# BOARDS & COMMISSIONS APPLICATION

Application Number P23-13

**P23-13**  
**Becco Excavating**

Property Owner: 1170 W Smith Road LLC  
Applicant: Ron Bengough Jr.  
Location: 1170 West Smith Road  
Zoning: I-1 (Industrial)  
Request: Site Plan approval for a multi-tenant industrial and office building

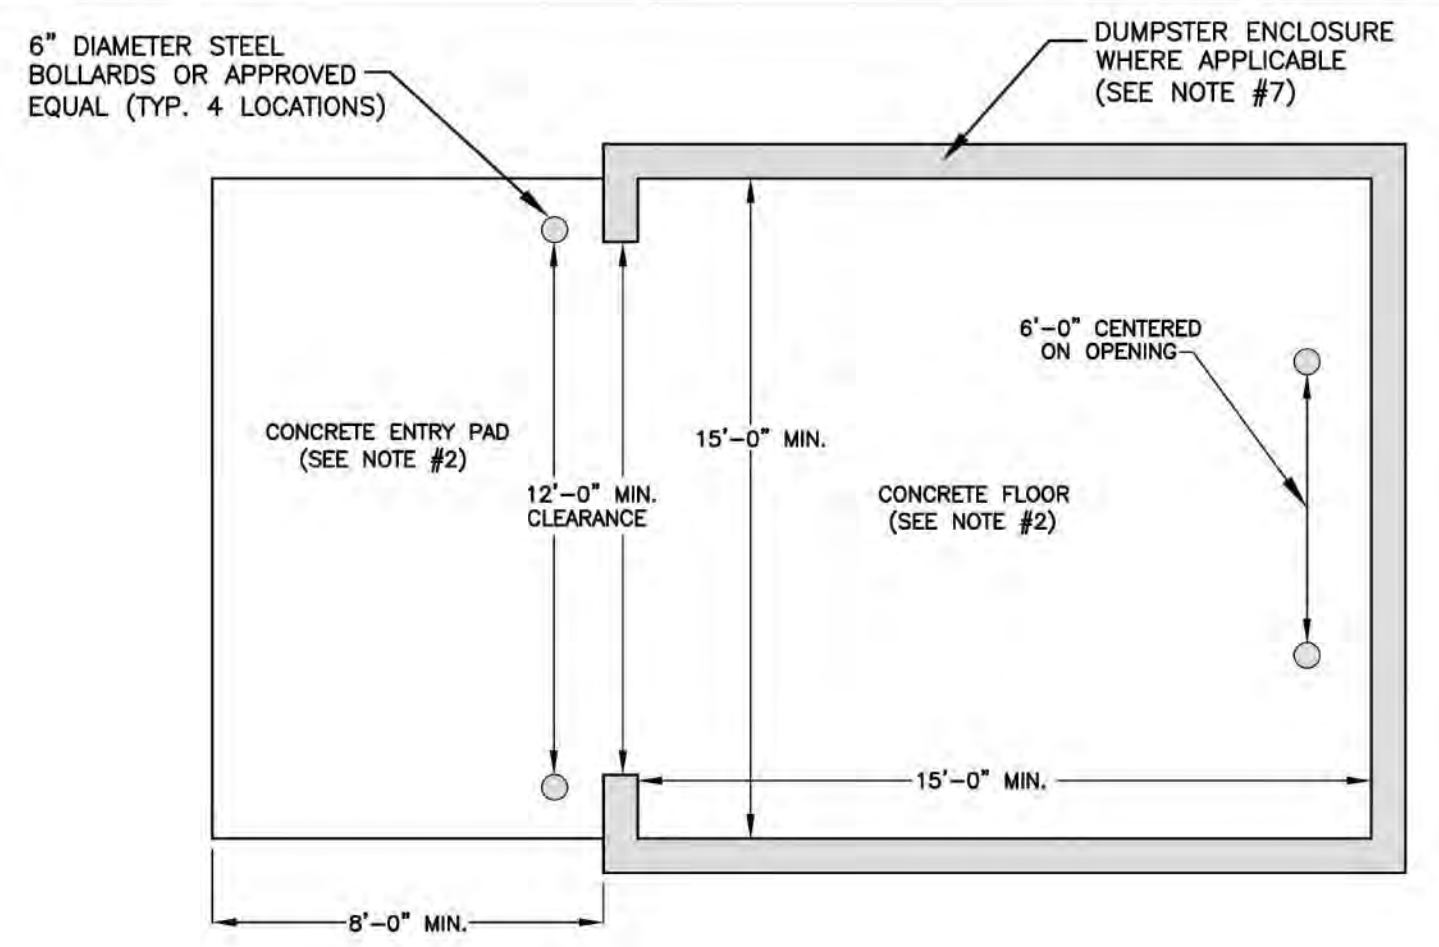
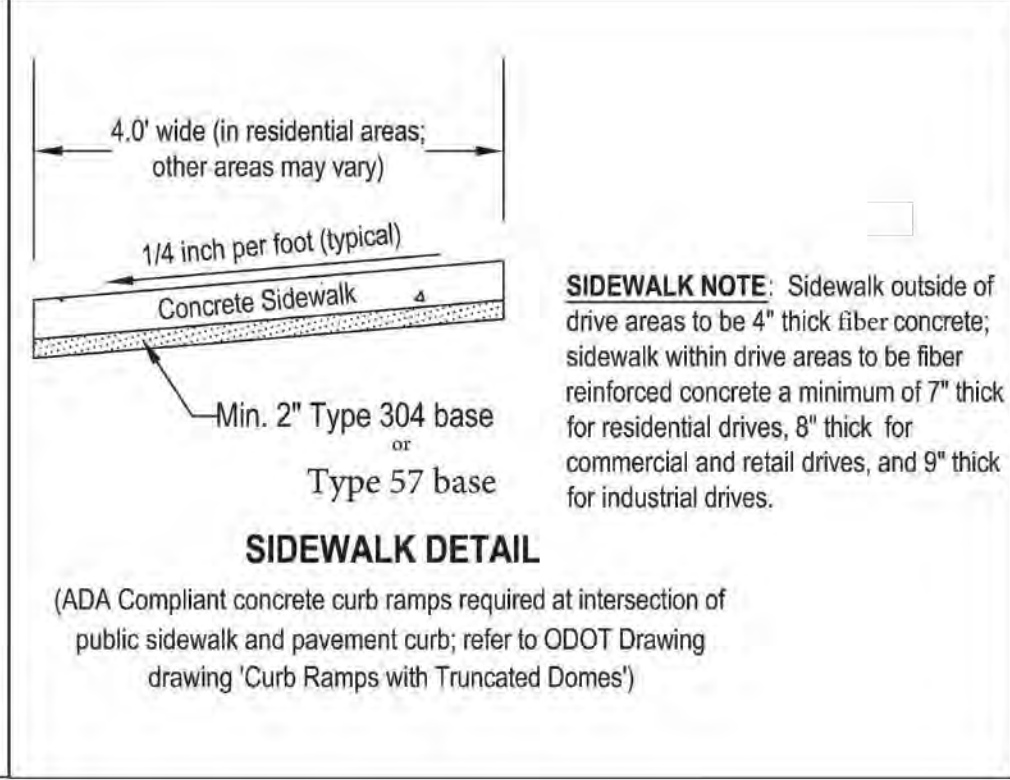
Trash Enclosure – A trash enclosure is shown on the west side of the site which is compliant with setback requirements. An enclosure is noted, but the height and material are not indicated.

- (1) A detail shall be provided for the trash enclosure indicating screening complying with Section 1155.05.
- (2) Exterior lighting information shall be provided complying with Section 1145.09(c) including a photometric plan, full cut-off fixtures, and a maximum lighting height of 25 ft.

SHEET NO. a3.1

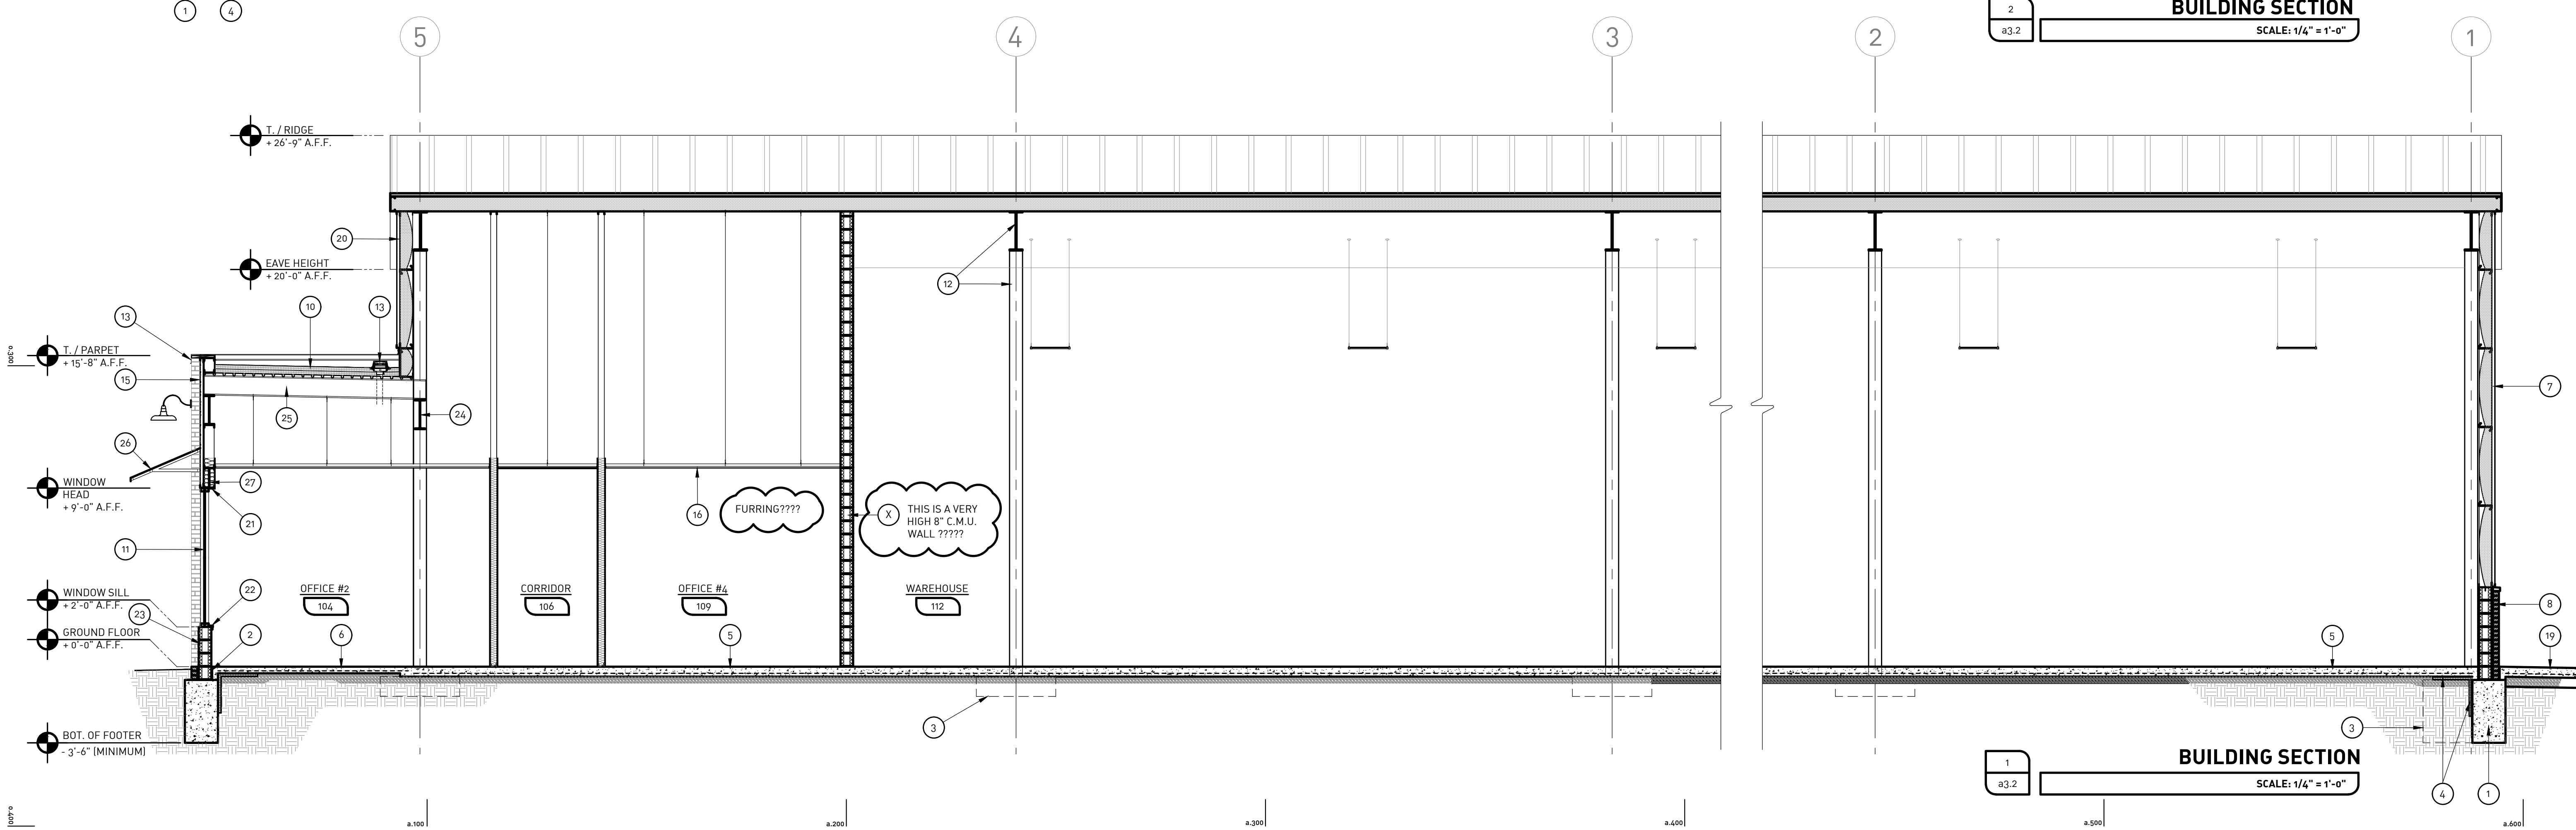
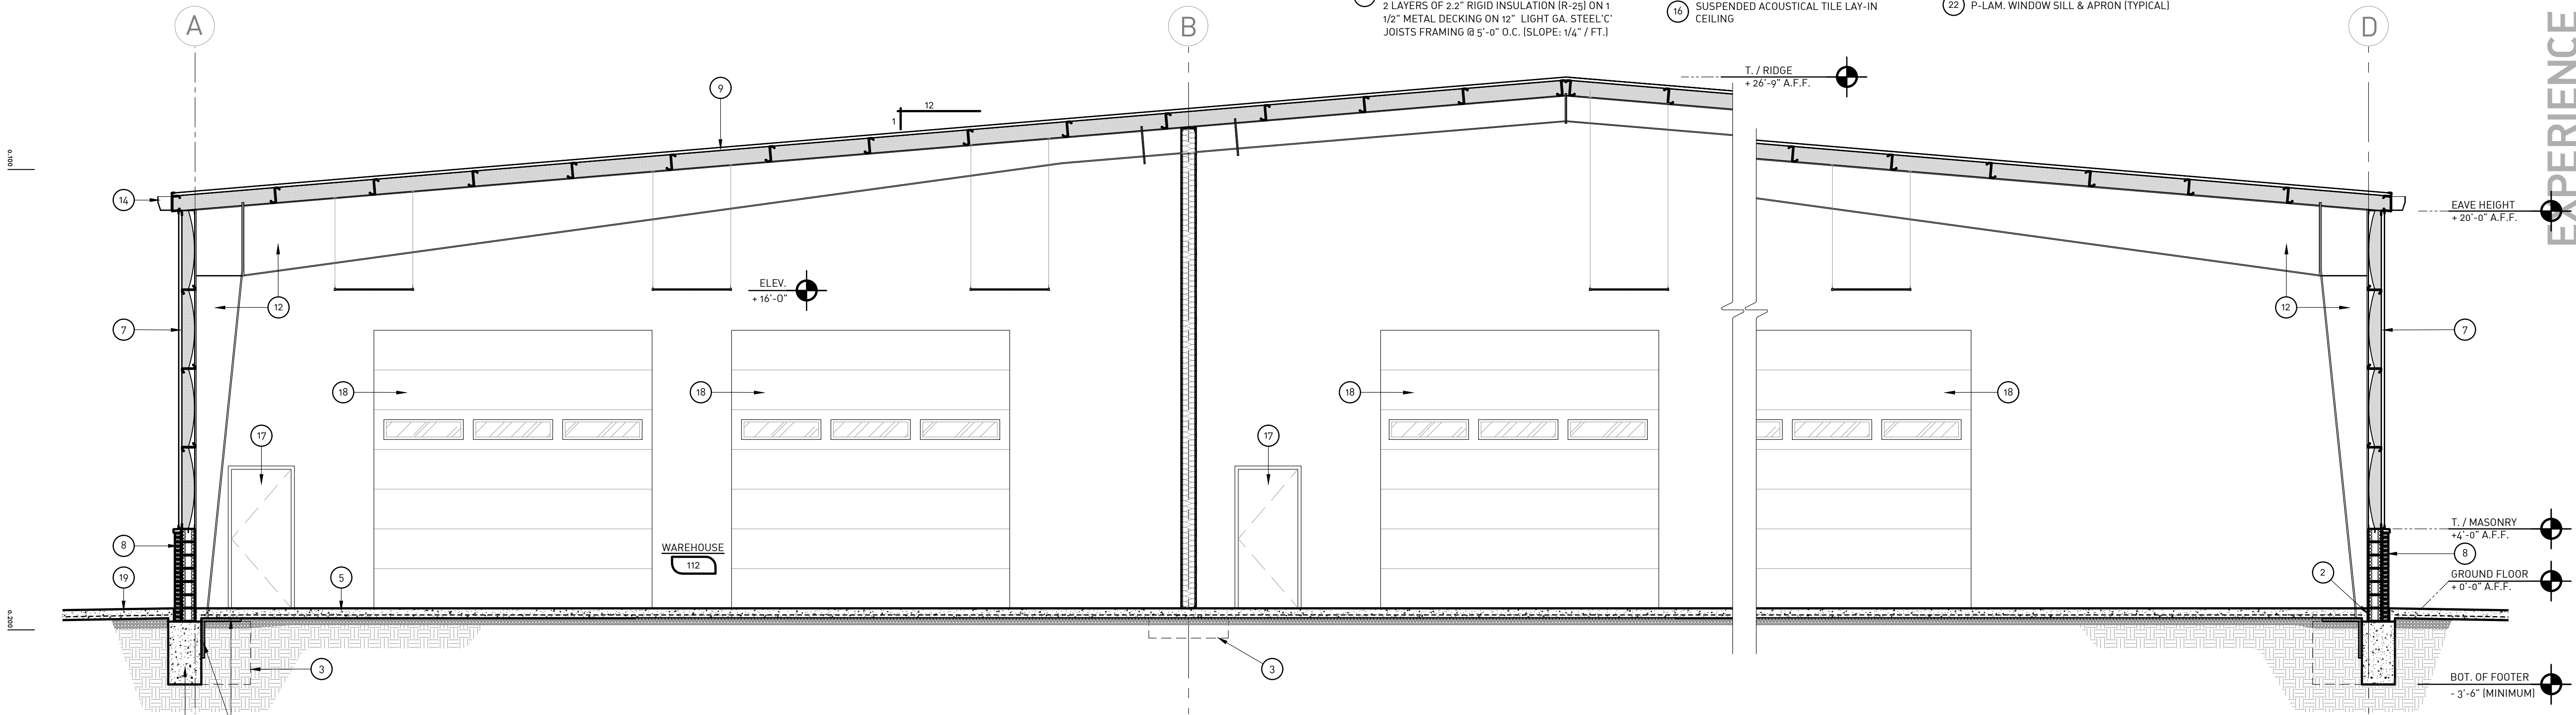
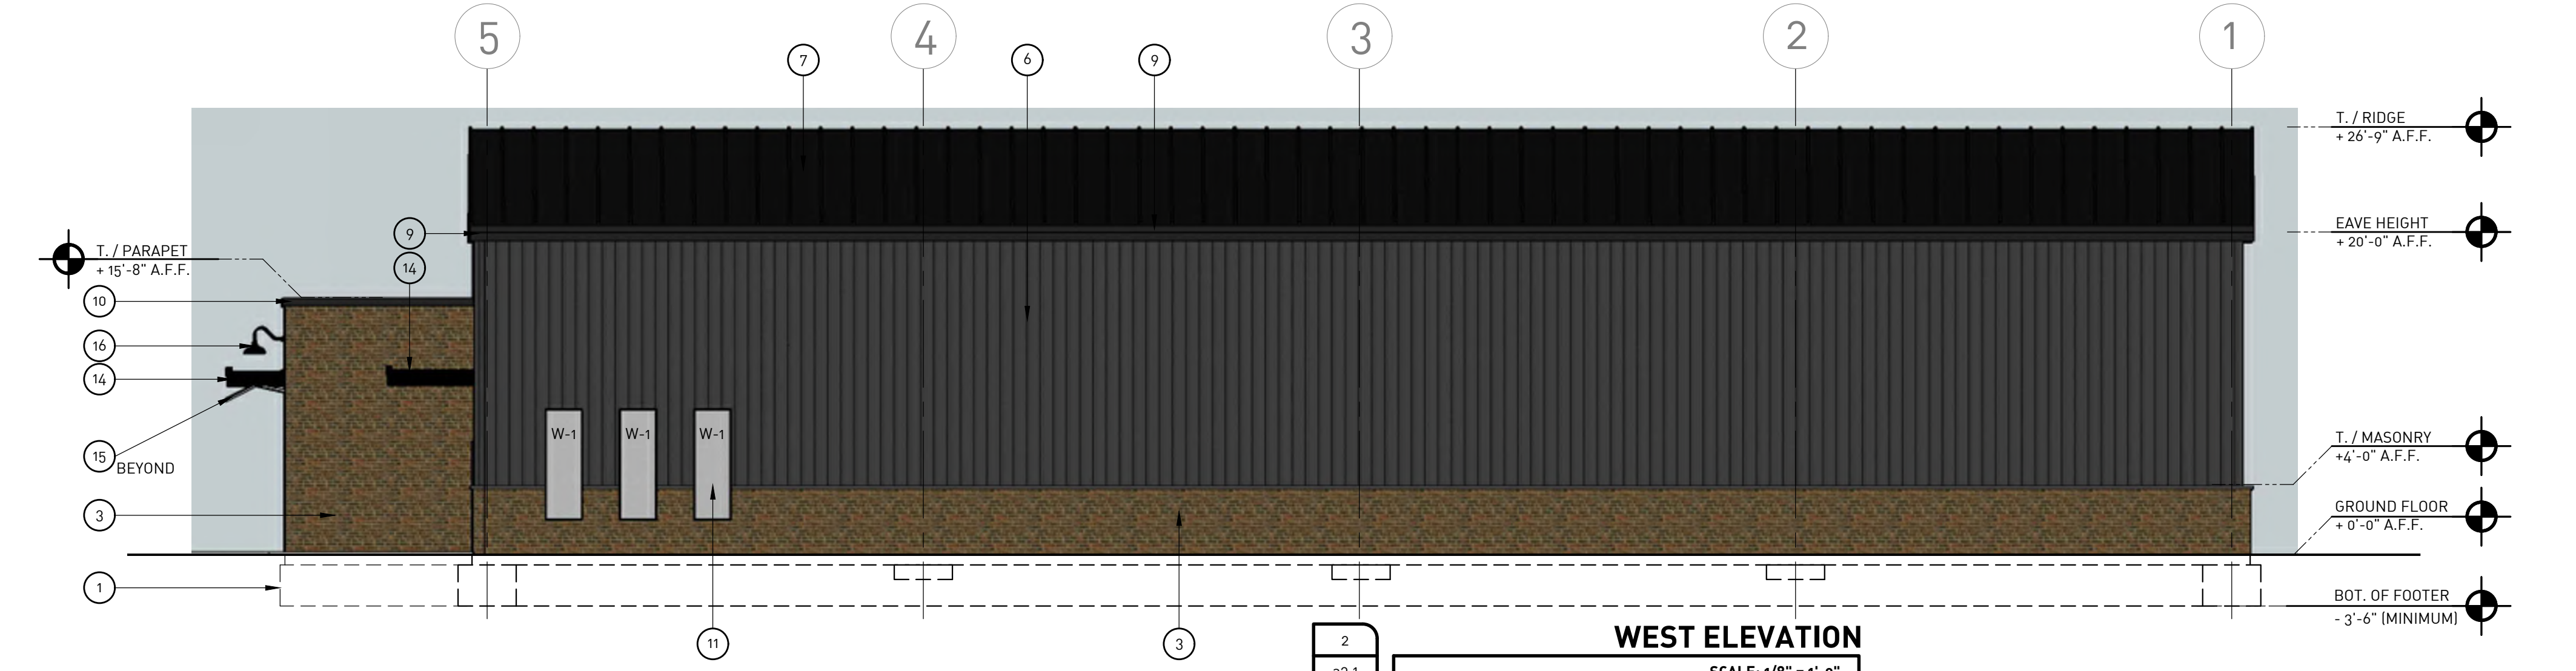
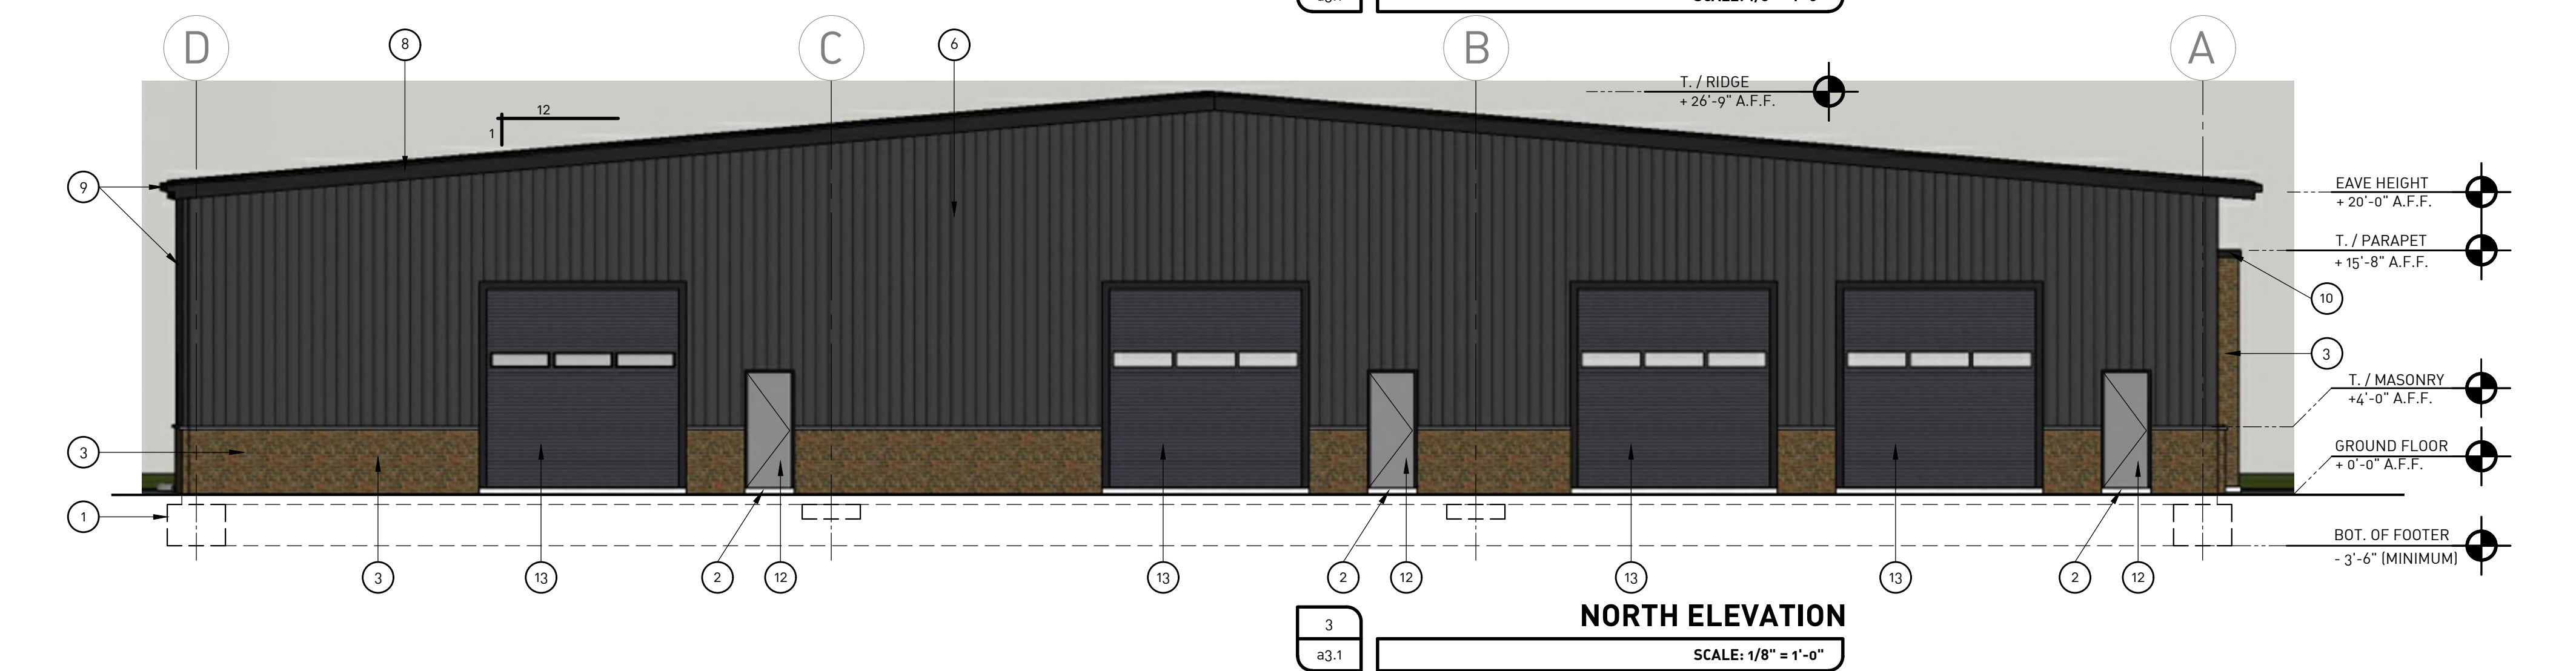
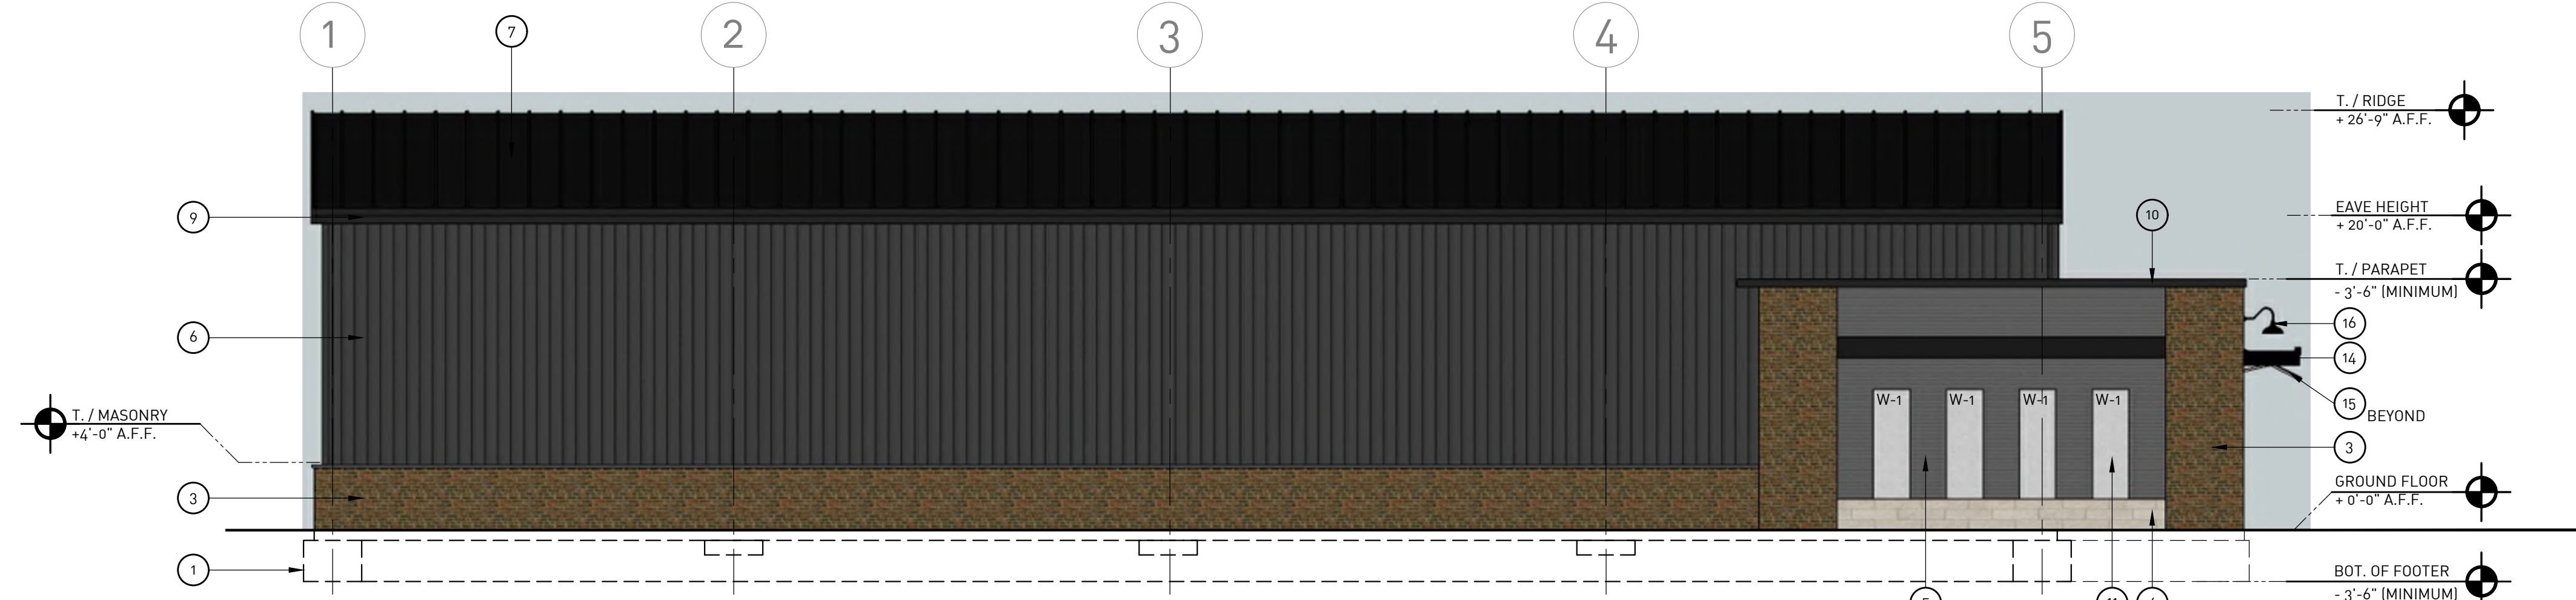
Architectural plans illustrate an attractive industrial building predominantly composed of dark vertical metal siding and brick veneer accents. Office areas in the front of the building incorporate windows, glass door areas, and brick veneer columns.
